SB-10054759-2733

SI B61 16 13
General Electrical Systems

Service Action: Check and, If Necessary, Replace Battery

E93

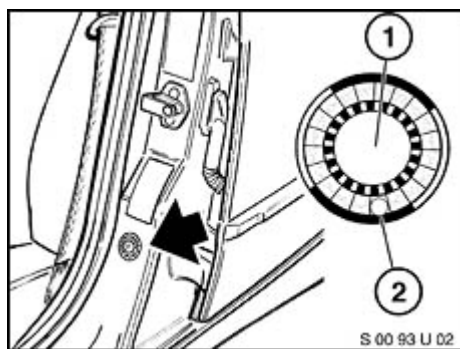
Check the installed battery and determine if the battery housing is white and produced by “Banner,” as indicated by the identification below.

NEW If the battery housing is white and has the “Banner” identification, replace and register the battery (select “1 Enter battery replacement: Same capacity” during battery registration) as per ISTA Repair Instruction 61 21 010, “Remove and Replace the Battery.”

NEW Note: In this special situation, the coding conversion with ISTA/P is not required when replacing the original Lead-acid battery with an AGM battery.

NEW If the battery’s housing is black and does or does not have the “Banner” identification, no further repair is needed. Install the label code and refer to the applicable warranty information section.
